# PERMIT

SEWAGE DISPOSAL SYSTEM

SUBDIVISION King's Gift ROAD 2831 KINGS GIFT DRIVE 11778 Route 144 LOT 9

# APPLICATION

A 30230

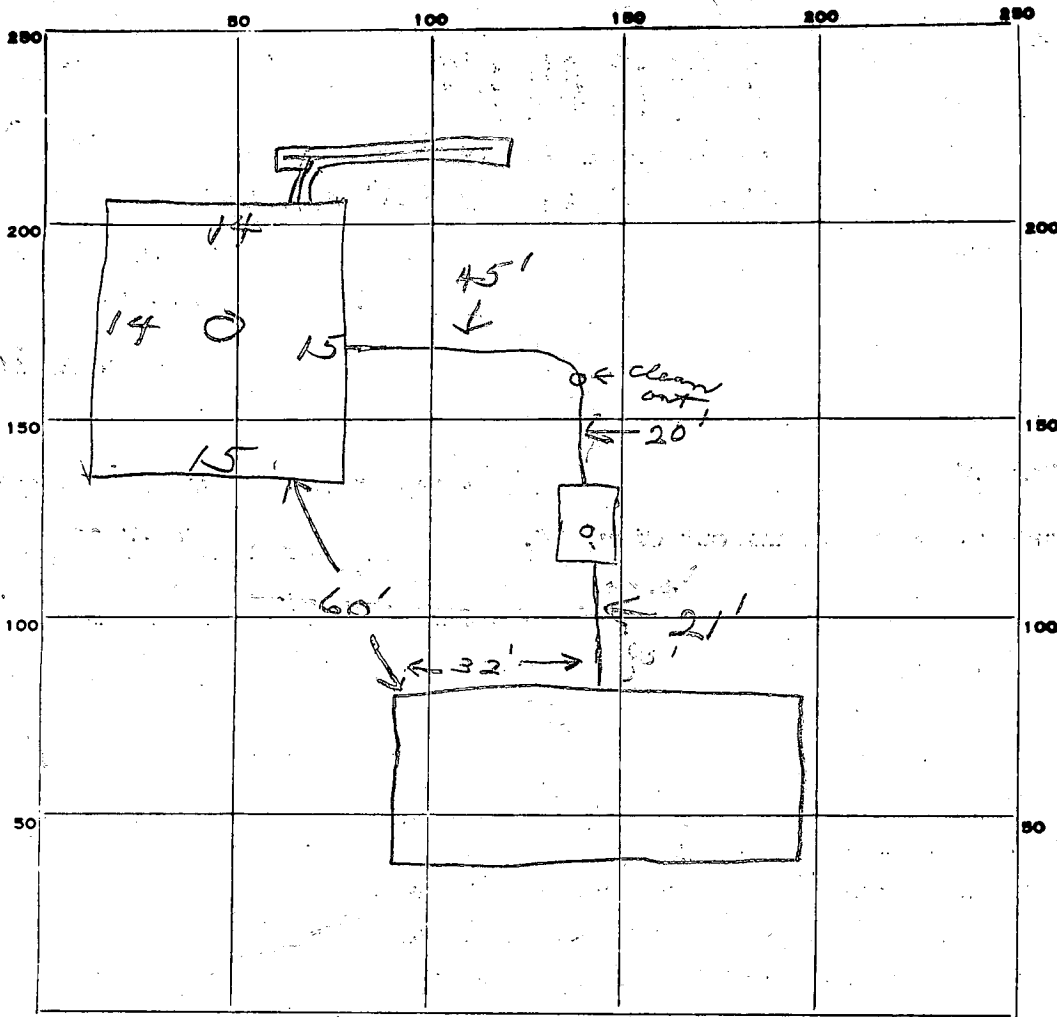
2 ~~Shallow Trenches from 3 1/2 to 6 1/2 feet below original grade. Two (2) - 85 foot trenches to be 3 feet wide with 3 foot stone under pipe. Trenches to have 125 sq. ft absorbent side wall area per bedroom below inlet. Inlet - 3 feet below grade. Trenches to be 15 feet apart - center to center and to run on contour of land. Trenches require 2 inspections - before and after stone in. LOCATION: Trenches to be in area as shown on approved house plan as revised on 7/31/80. NOTE: TRENCHES NOT TO BE CONNECTED IN SERIES. MUST USE DISTRIBUTION BOX OR T'S AND CONNECT TO END NEAREST SEPTIC TANK.~~

REMARKS 10/27/80 Short on area, need 5ft more trench  
also clean out trench filled in to 8' + 9' needs to be 11' deep  
OK to cover systems to trench. JS + SK  
10/27/80 OK to cover all work. SK + JS

REVISED 10/20/80 @ SITE - SEE REVISED SPECS  
PLANS APPROVED BY D.W. Monaghan/C.B. Streaker DATE 6/6/78 & 7/31/80

P 30828

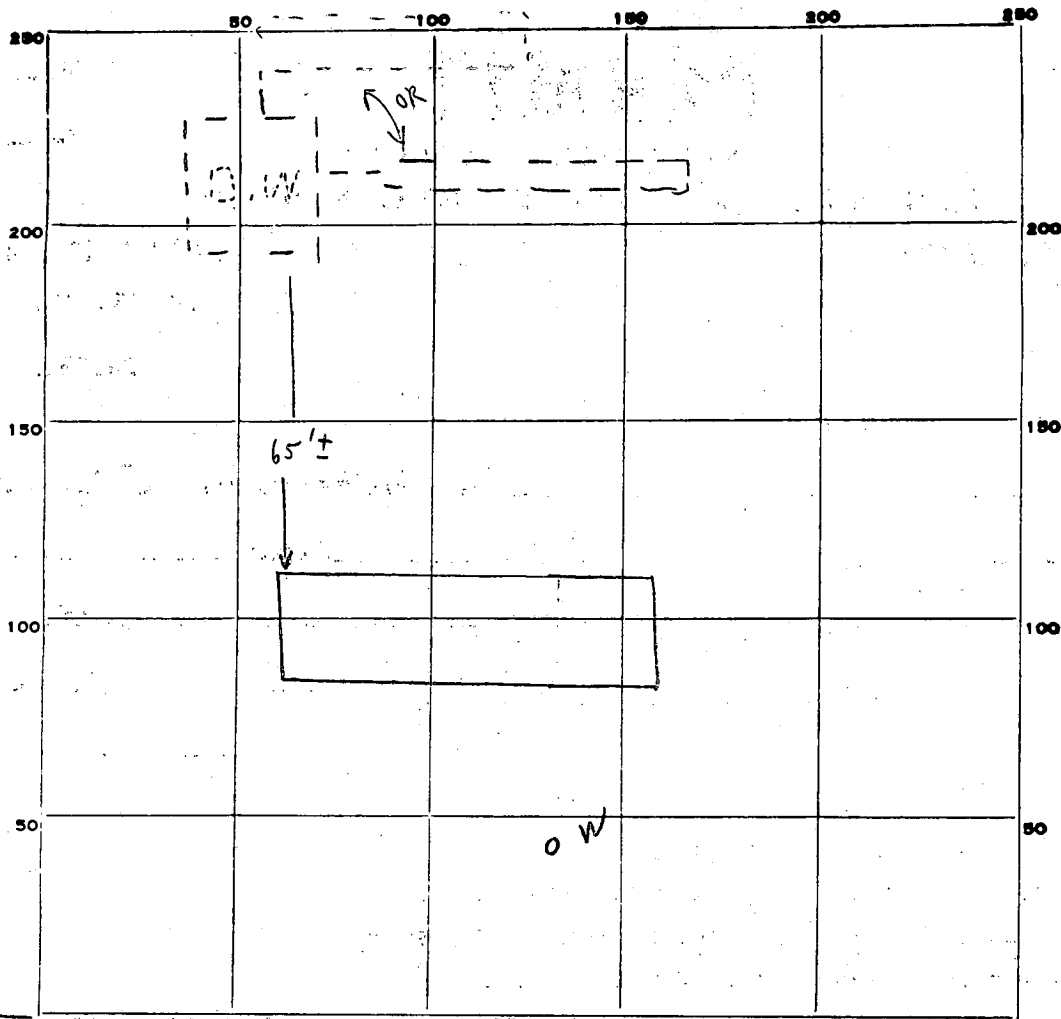
REVISED SPECS - 1 15' X 15' DRY WELL INLET 3'-4' BELOW

ORIGINAL GRADE - EFFECTIVE AREA 4'-11' TOTAL 420 SQ. FT. + 1 TRENCH

AFTER 5' EARTH BUFFER 15' LONG; EFFECTIVE AREA 4'-11';

7' OF STONE UNDER PIPE TOTAL 105 SQ. FT.

LOCATION OF DRY WELL  
65'-75' BACK FROM LEFT  
REAR CORNER  
OF HOUSE.

+ TRENCH TO RUN  
PARALLEL TO HOUSE

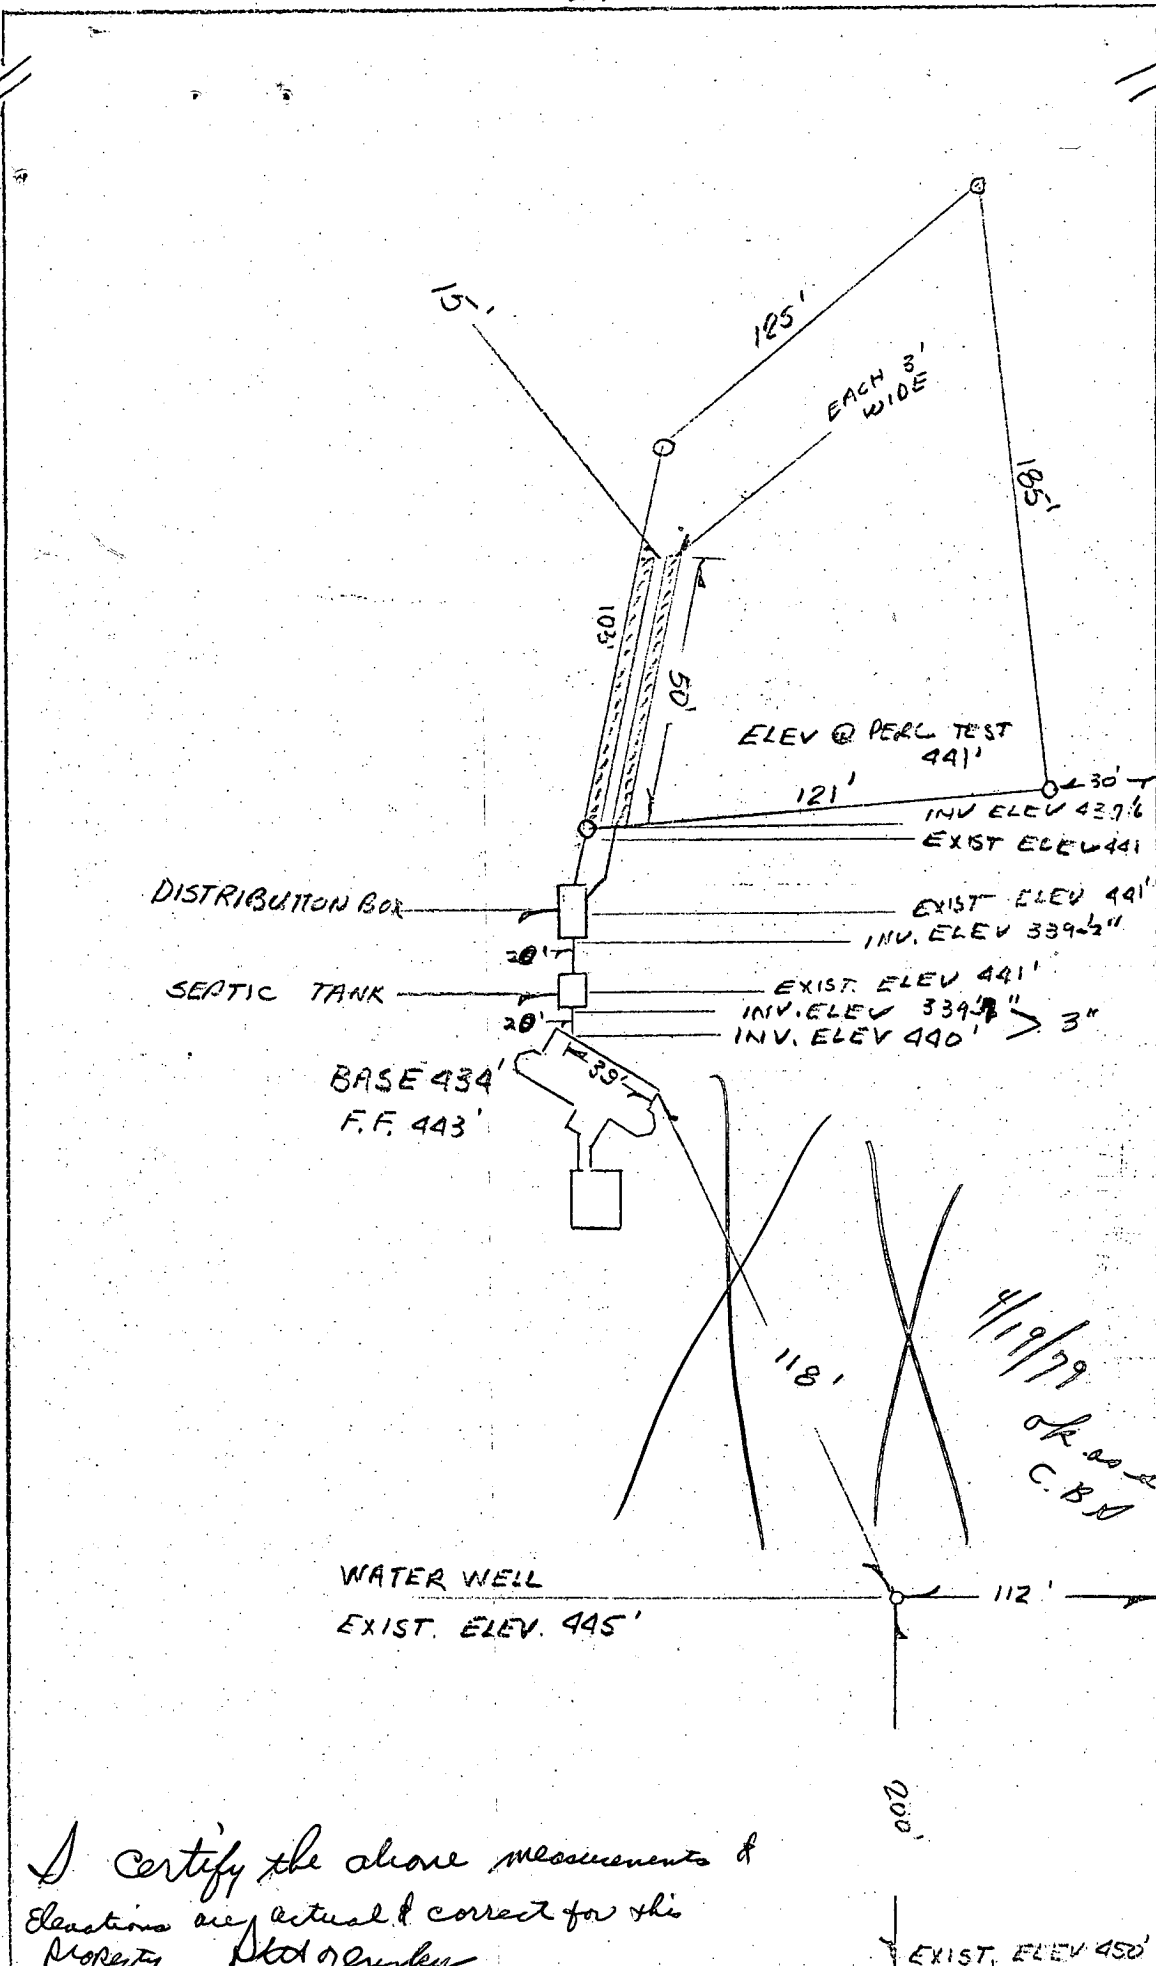
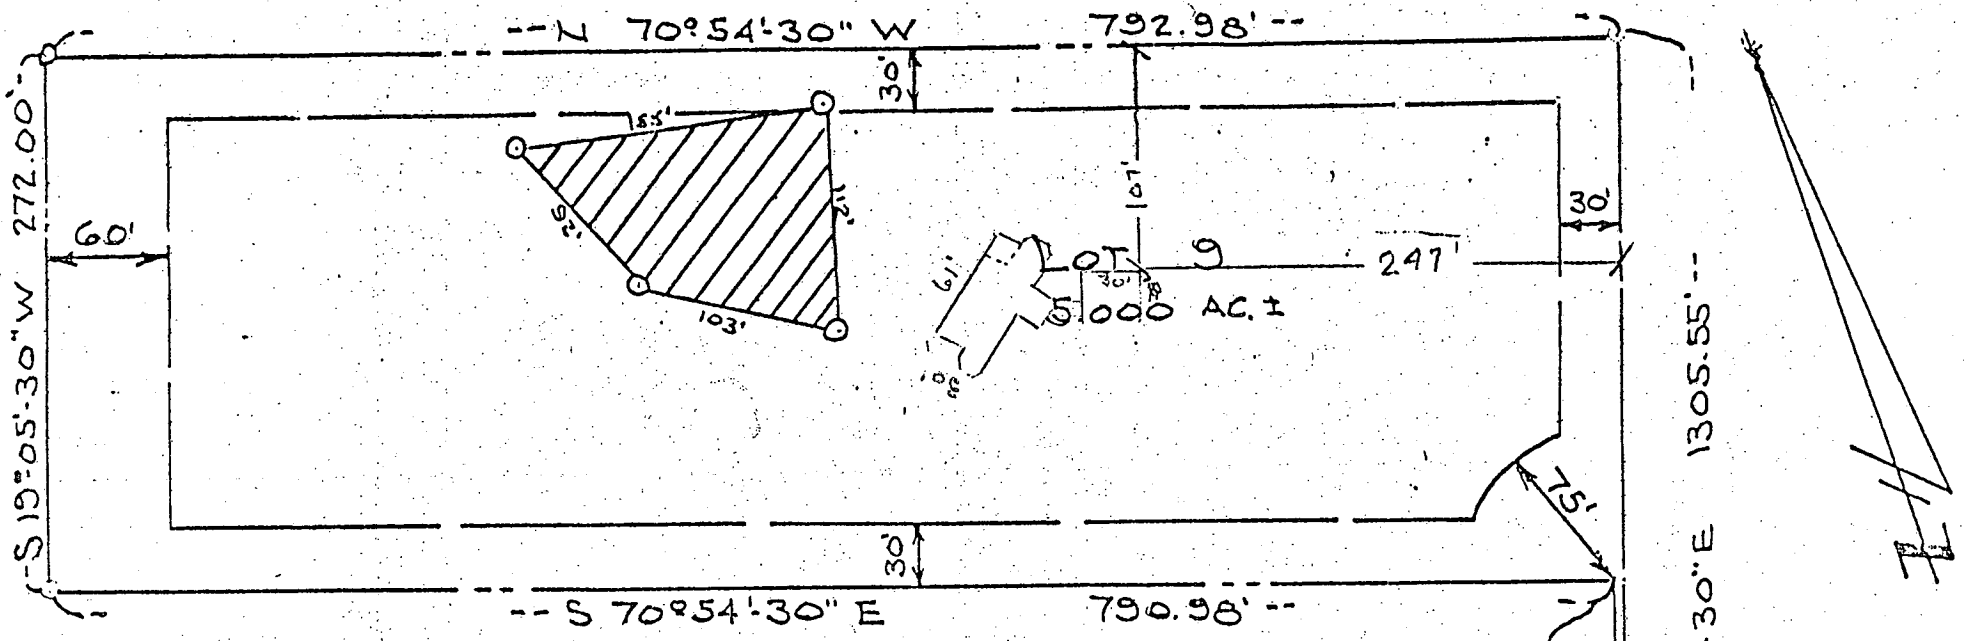
4/19/79  
ok as shown  
C. B. D.

7/31/80  
See revised  
C. B. D.

NO SCALE  
 REVISED 10-3-79

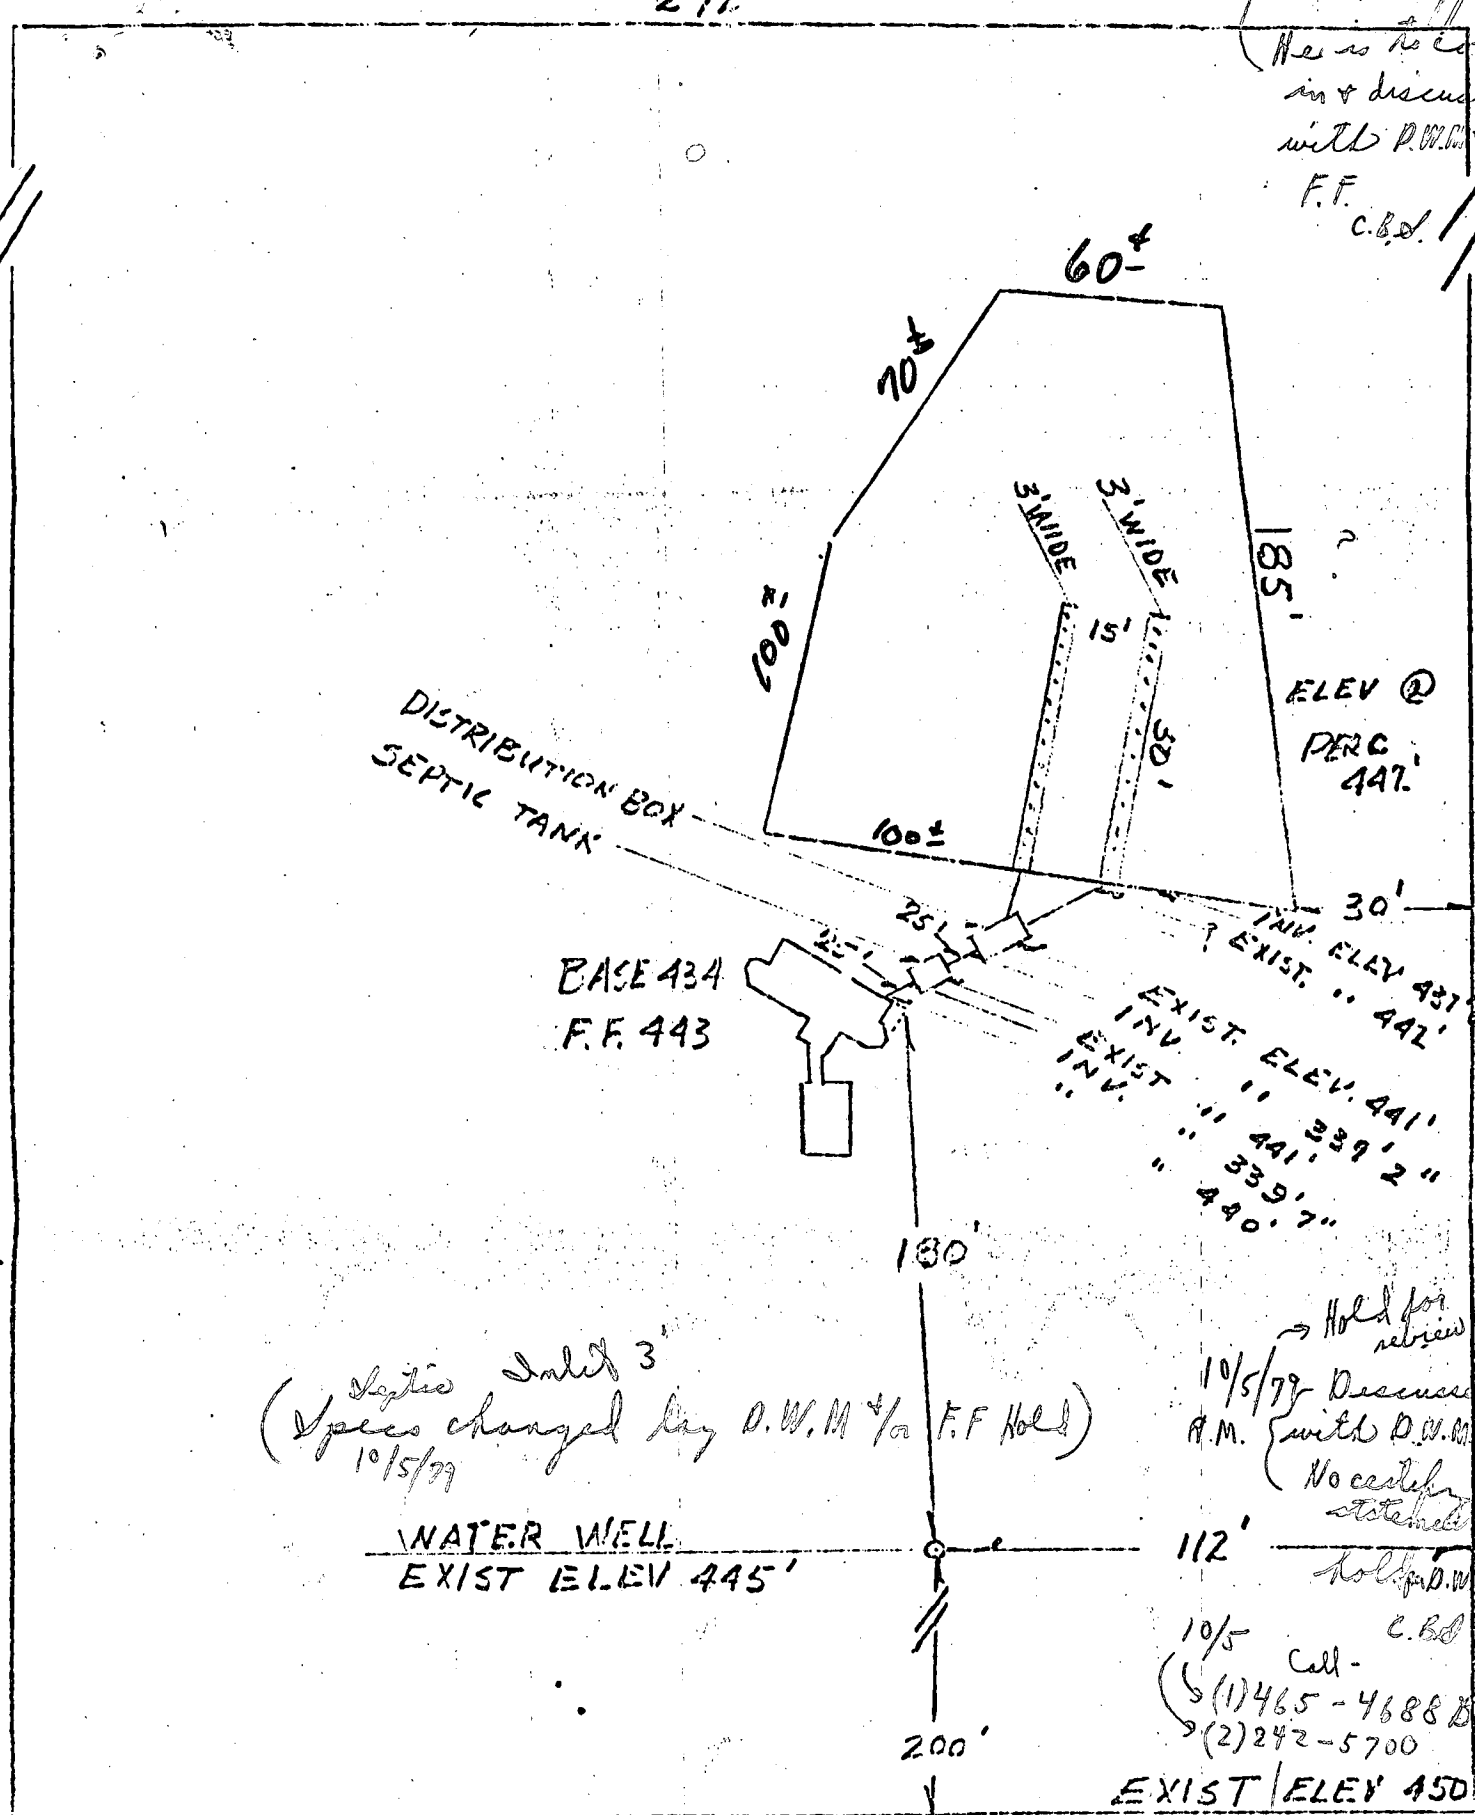
10/9/79 (Mr Horensky  
 called to office  
 He is to come  
 in & discuss  
 with P.W.M. & I  
 F.F.  
 C.B.S.

Septic Inlet 3'  
 (Specs changed by D.W.M. & F.F. Hold)  
 10/5/79

Hold for review  
 10/5/79 Discussed  
 A.M. (with D.W.M.)  
 No certificate  
 statement  
 hold for D.W.M.  
 C.B.S.  
 10/5 Call -  
 (1) 465-4688 (Bureau)  
 (2) 242-5700
